**Re: Enbridge Gas Inc. (Enbridge Gas or the Company)
Ontario Energy Board (OEB) File No. EB-2022-0111
Bobcaygeon Community Expansion Project
Change Request No. 1**

Bobcaygeon Community Expansion Project Change Request #1

Bobcaygeon Community Expansion Project – Change Request #1

Attachment 1 Revised Project Route Map

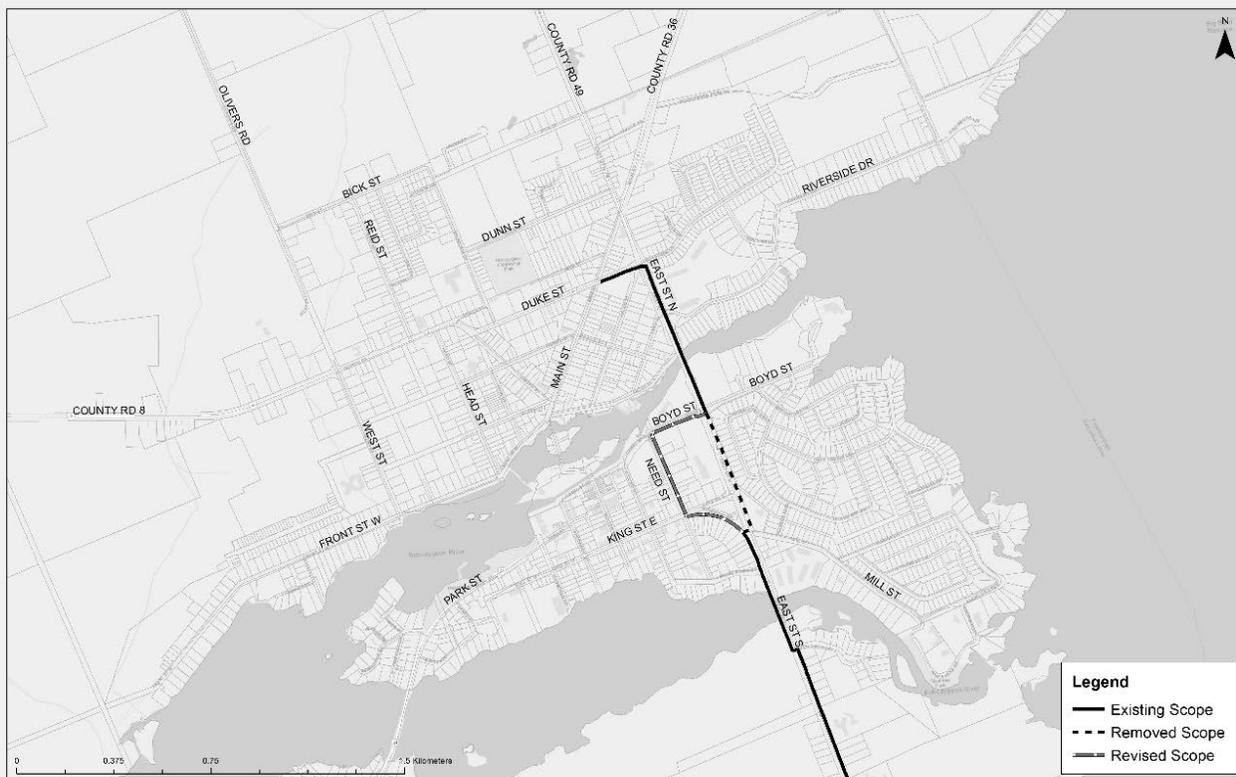
2. The scope of this Change Request is the Company's proposal to re-route approximately 490 m of NPS 6-inch high pressure polyethylene (HPPE) distribution pipeline on East Street South between Mill Street and Boyd Street to a more constructable area along Kingsway Drive, King Street, Need Street, and Boyd Street. The new route will add approximately 350 m of NPS 6 HPPE distribution pipeline to the Supply Lateral, and as a result will remove approximately 750 m of ancillary distribution pipeline from the scope of the Project. A map identifying the removed and revised scope is included at Attachment 1.

3. The purpose of this Change Request is to avoid excavating through (and installing gas main within) shallow bedrock in a location that is not proposed to provide gas services to any customers in scope of the Project. The actual extent of challenges of working through rock in this area was unforeseen and was realized when construction crews began to break rock. At the rate and conditions experienced, several weeks would be added to the construction schedule. Re-routing approximately 490 m of gas main in this area of East Street South is expected to avoid both delays to the Project schedule as well as potentially significant cost impacts (described below).
